# CITY OF NEWTON, MASSACHUSETTS

SUBJECT: Petition #178-10 of EDWARD TAPPER PLOTKIN for a SPECIAL PERMIT/SITE PLAN APPROVAL to waive the minimum dimension of a parking stall and to waive the minimum dimension of an entrance/exit drive in order to relocate one of two existing tandem parking spaces at 64 EDDY STREET, Ward 3, West Newton, on land known as Sec 21, Blk 37, Lot 14, containing approximately 4,663 sf of land in a district zoned MULTI RESIDENCE 3. Ref: Sec 30-24, 30-23, 30-19(g)(2), (3), and 30-19(m) of the City of Newton Rev Zoning Ord, 2007.

## **Zoning Review Memorandum**

MEMORANDUM

VTP  
ASSOCIATES

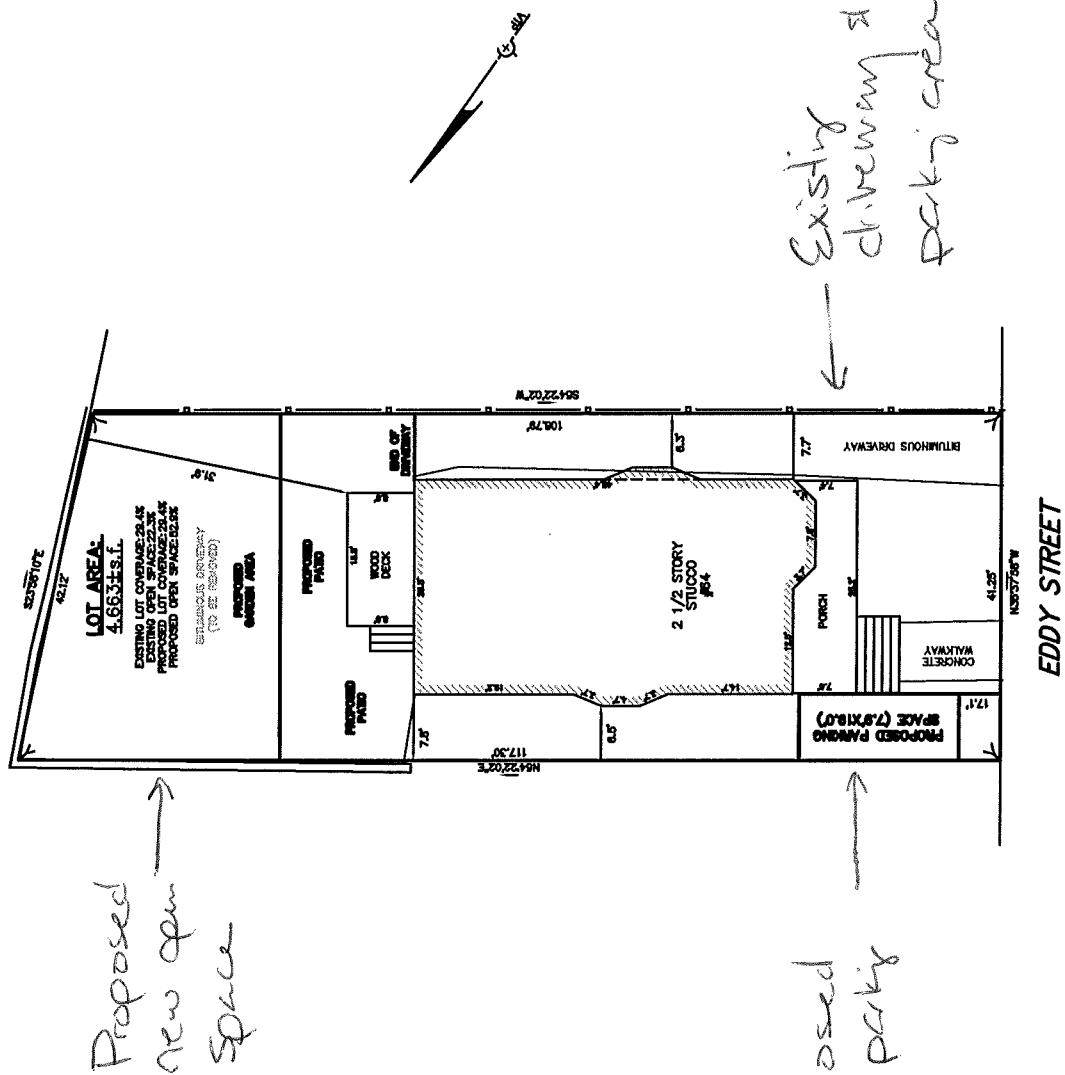
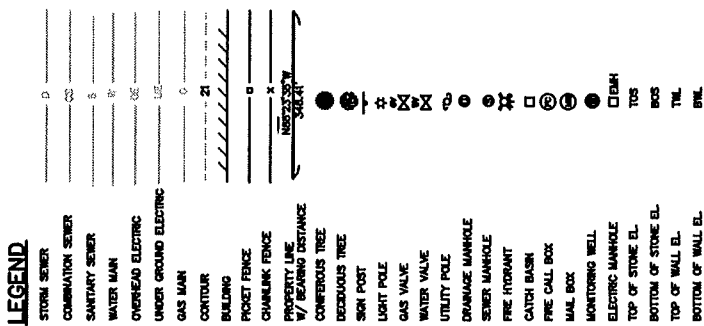
The petitioner proposes to locate an additional curb cut and parking stall in the northwest corner of the lot. The petitioner is seeking a waiver for a substandard sized stall of 7.9' x by 19' where 9' x 19' is required. Although this stall would be located in the front and side setback one parking stall per dwelling unit may be located within required setback and sideline distances. The proposed new curb cut is only 7.9 feet wide where 12 feet are required, for which the petitioner is seeking a waiver.

*Although there appear to be some residences in the immediate neighborhood with two curb cuts and parking in the front setback, the Planning Department is concerned that the proposed parking arrangement will adversely affect the character of the neighborhood. The Planning Department also notes that the proposed new curbcut is adjacent to the neighbor's driveway (which is not shown on submitted plans). If the northerly abutter decides to place a fence or car on the property line, there may not be sufficient room given the proposed undersized stall.*

The Planning Department suggests the petitioner consider removing the bay window along the south side of the house, which is the pinch point in the existing driveway. Although this would continue the tandem parking arrangement, it would prevent parking in the front setback and would not be much narrower than the proposed new parking stall should the northerly abutter decide to put up a fence on the property line.

5. Section 30-19(g)(2) sets the minimum dimensions of an individual parking stall at nine feet wide by 19 feet long. The proposed new parking space is only 7.9 feet wide. A special permit from the Board of Aldermen under Section 30-19(m) is required to allow this smaller dimension.

6. Section 30-19(g)(3) requires entrance and exit drives to be a minimum of 12 feet wide. The proposed new driveway is only 7.9 feet wide. A special permit from the Board of Aldermen under Section 30-19(m) is required to allow this smaller dimension.

The applicant is proposing a new paved parking stall for one vehicle with the front setback. The location is directly adjacent to the neighbor driveway which is right on the property line, which the site plan does not show. The applicant needs to remodel the sidewalk and curbing in conformance with the City's Construction Standards for a driveway apron should this permit be approved. As a large area of existing asphalt (parking spaces) in the backyard is being removed and re-sodded, there is no need for any drainage improvements associated with the new parking stall.

Please note that the City standard for a pull in driveway is 9' x 19' the proposal is for a 7.5' x 19' this does not meet the minimum requirement which may be difficult for the neighbor's vehicle entering and exiting the vehicle in their own driveway.
